SERVICE INFORMATION LETTER

SERVICE LETTER NO. 0043

Subject: Inspection of 28-16192 and 28-16339 Push-Pull Control Rods

Models: F-28A; 280 (With Cabin Heaters manufactured Prior February 18, 1975)

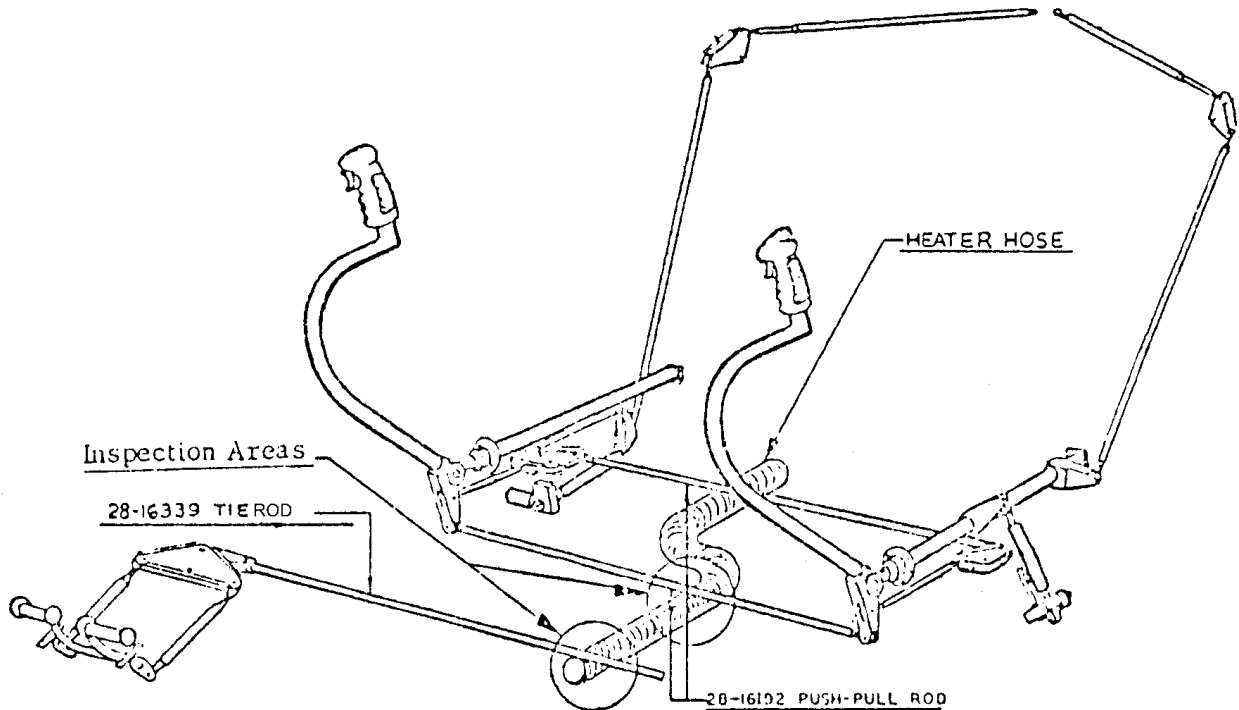
Three instances have been reported of chafing between the forward heating hose and the 28-16192 and 28-16339 push-pull control rods. The inspection areas are illustrated below.

Any wear on the aluminum control rods exceeding .015 depth should warrant replacement. Extra clamping may be required to obtain clearance between the heater hose and the push-pull control rods. Normal clearance is about .38 in.
